Impact of Using OMAouter to Calculate TDECQ

Ahmad El-Chayeb, David Leyba, Ryan Chodora
Keysight Technologies

- The CRG adopted a change to use OMA_{outer} as defined in clause 180.9.5 for the power penalty calculation (TDECQ)

OOMA(dBm) at FFE Output vs. OOMA (dBm) at FFE Input

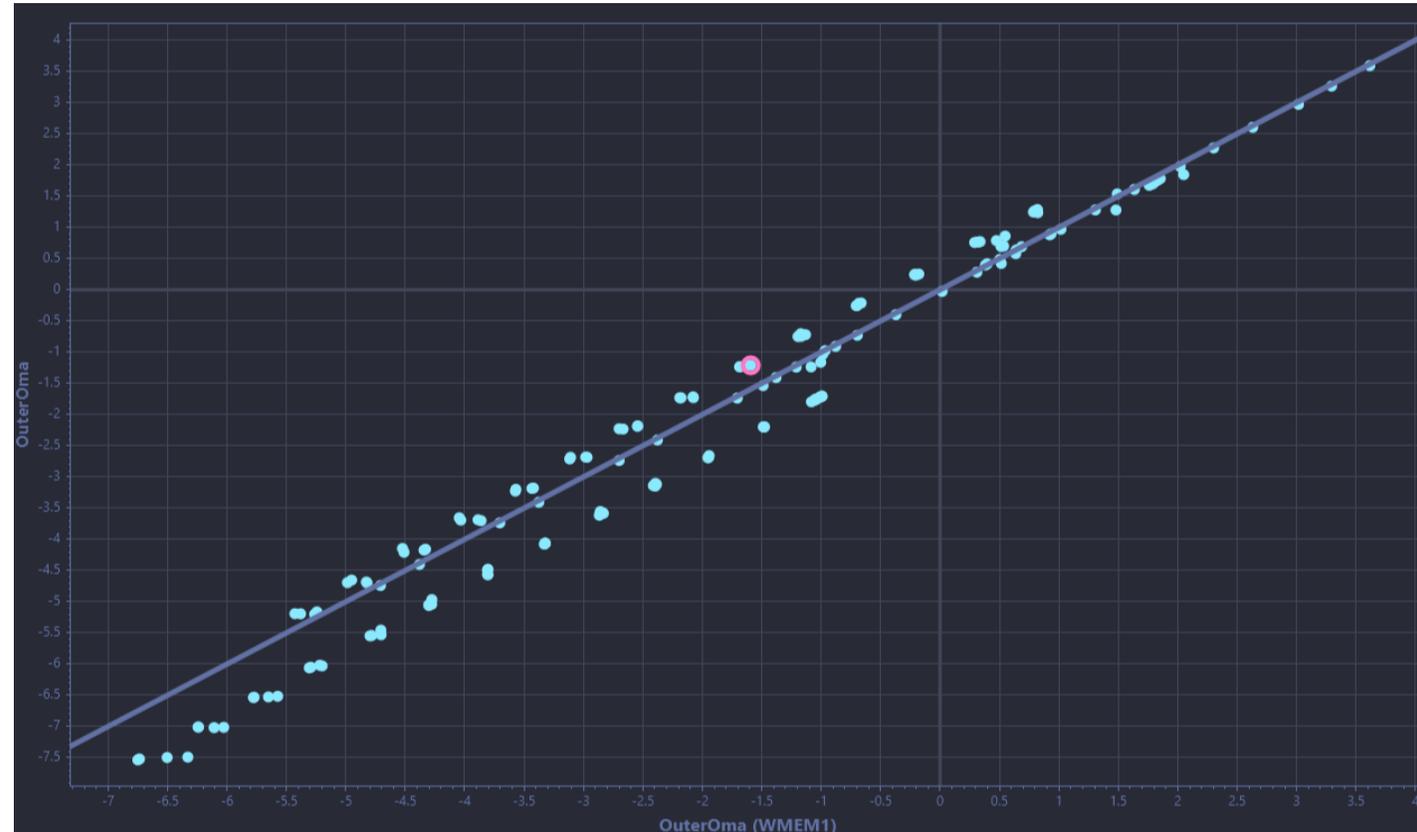
- Outer Optical Modulation Amplitude (OOMA) of various 200G-per-lane devices was measured at the output (y-axis) and the input (x-axis) of a 15-tap FFE equalizer.
- For the highlighted waveform, OOMA measured at the output of the 15-tap FFE is higher than the OOMA measured at the input of the FFE equalizer.
- OOMA calculations for the highlighted waveform are compared at input and the output of a 15-tap FFE equalizer in the next slide.

OOMA Calculations for a Transmitter with Equalizable ISI

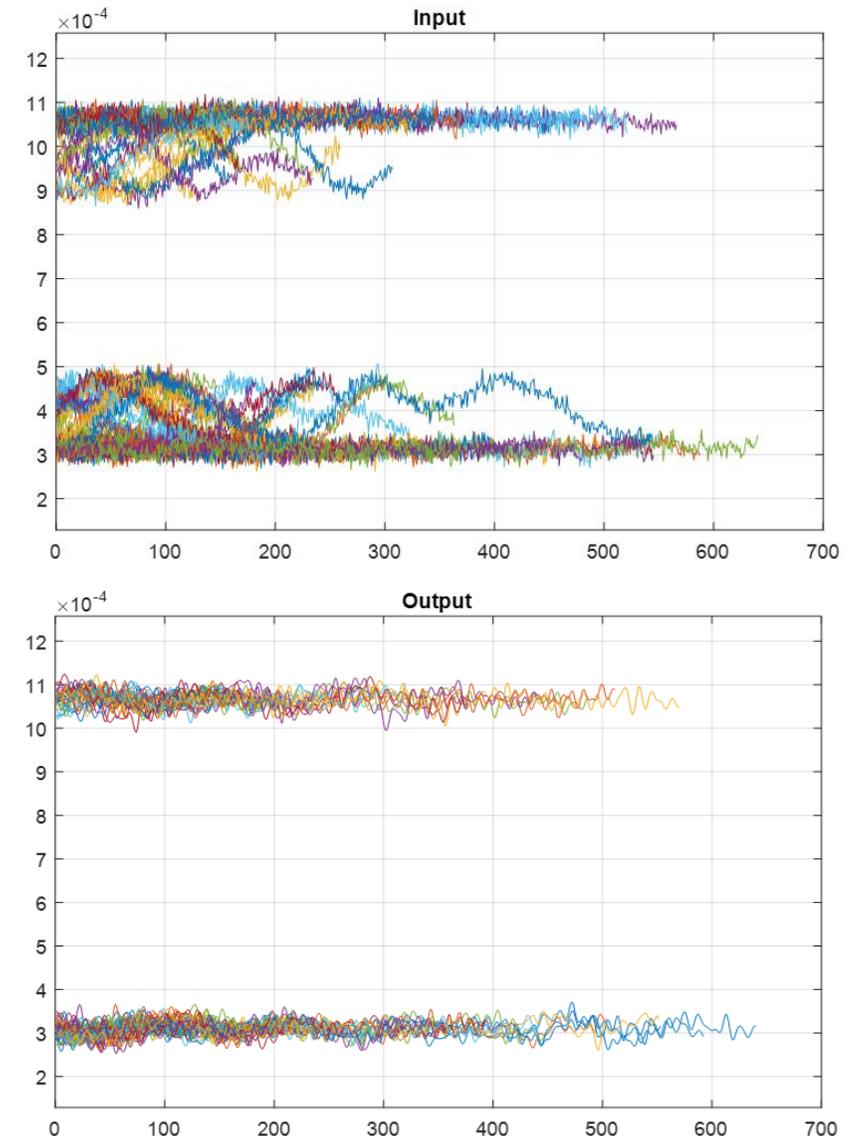
- The waveform values used to make OMA measurements for the highlighted point in the previous slide are plotted for the input and output waveforms.
- OOMA is calculated using all runs of 0's and 3's that meet the minimum CID requirement in the SSPRQ pattern.
- The average level of each run is calculated. These values are averaged as 0 or 3 levels.
- The unequalized waveform (input) shows a bouncing effect that reduce the OOMA measured compared to the OOMA value measured at the equalized waveform (output).
- The TDECQ value calculated using the input waveform will go down.

OOMA(dBm) at FFE Output vs. OOMA (dBm) at FFE Input

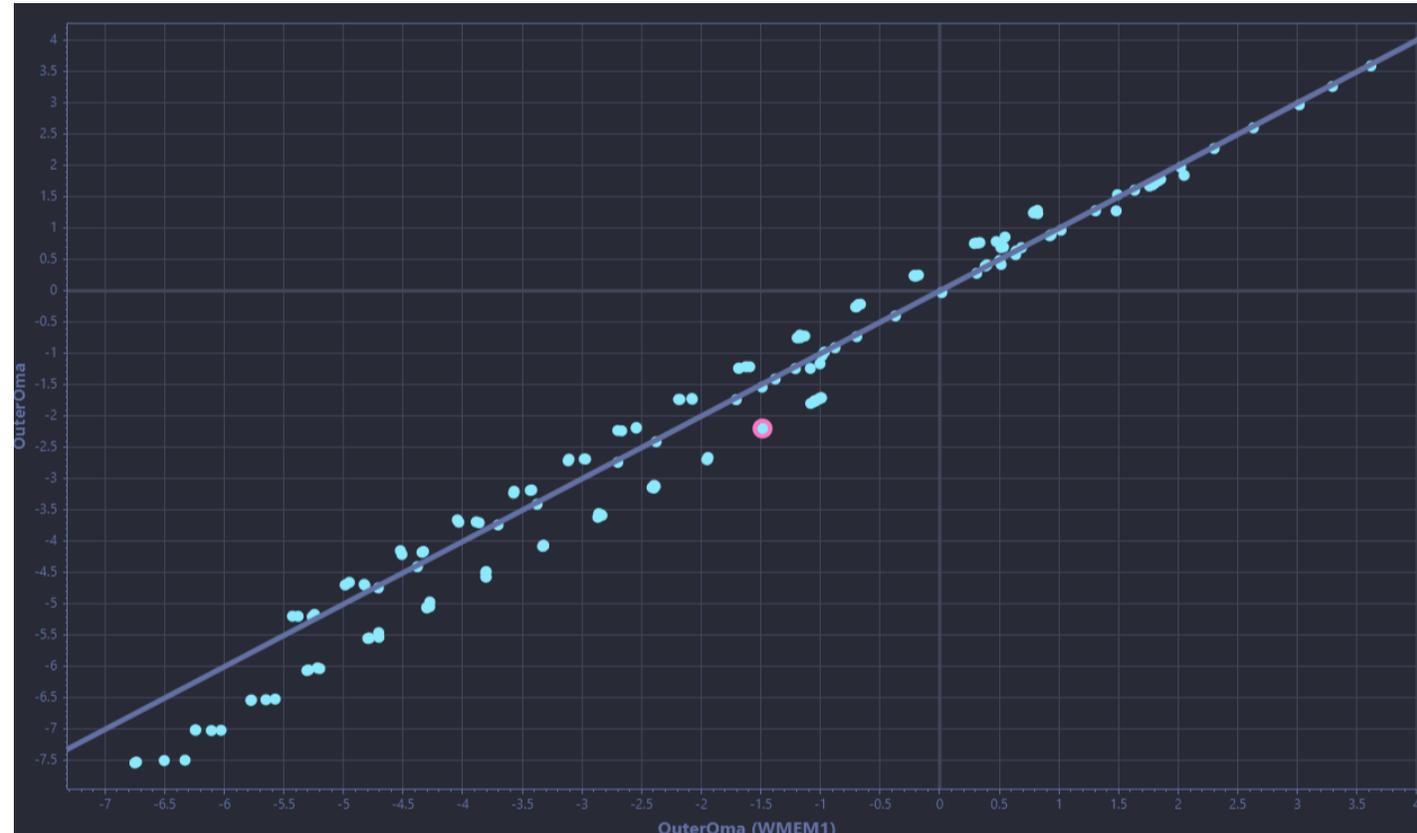
- Outer Optical Modulation Amplitude (OOMA) of various 200G-per-lane devices was measured at the output (y-axis) and the input (x-axis) of a 15-tap FFE equalizer.
- For the highlighted waveform, OOMA measured at the output of the 15-tap FFE is lower than the OOMA measured at the input of the FFE equalizer.
- OOMA calculations for the highlighted waveform are compared at input and the output of a 15-tap FFE equalizer in the next slide.

OOMA Calculations for a Transmitter with Overshoot

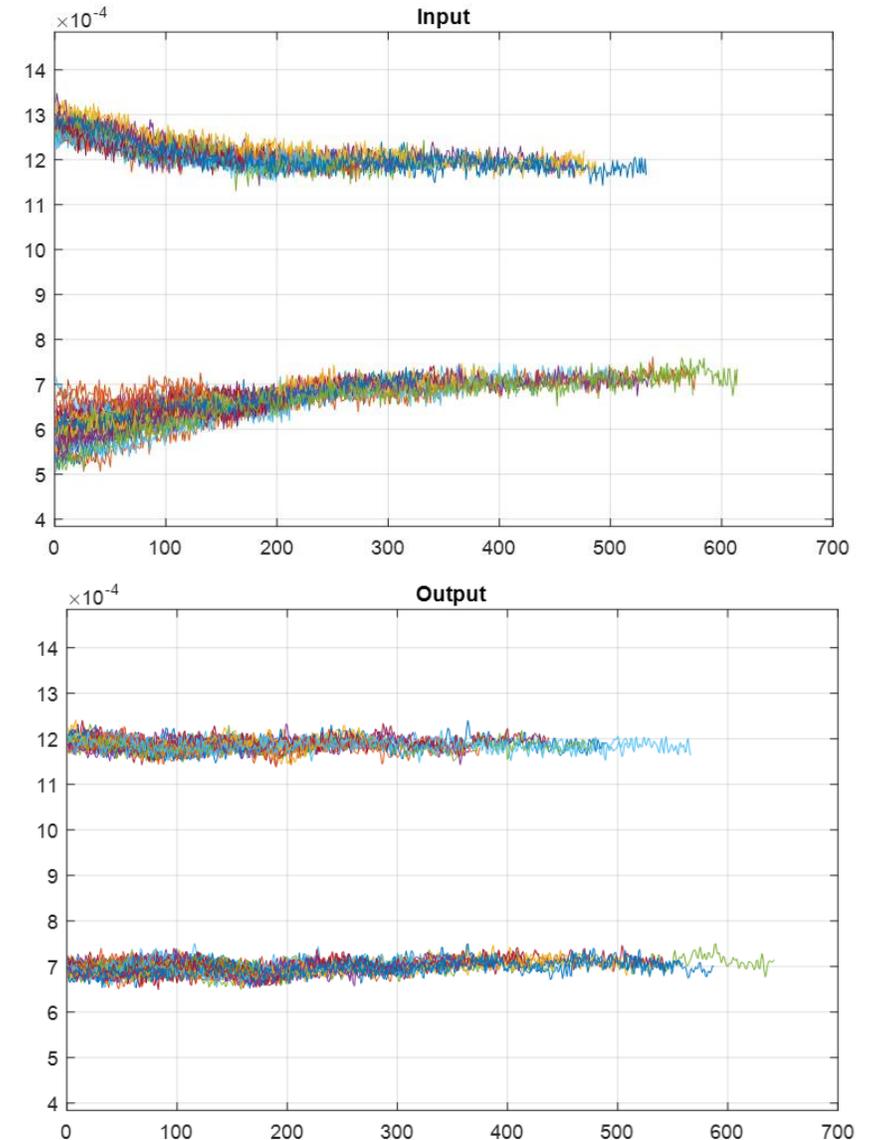
- The waveform values used to make OMA measurements for the highlighted point in the previous slide are plotted for the input and output waveforms.
- OOMA is calculated using all runs of 0's and 3's that meet the minimum CID requirement in the SSPRQ pattern.
- The average level of each run is calculated. These values are averaged as 0 or 3 levels.
- The unequalized waveform (input) shows an overshoot and a long tails effect that overestimates the OOMA measured compared to the OOMA value measured at the equalized waveform (output).
- The TDECQ value calculated using the input waveform will go up.
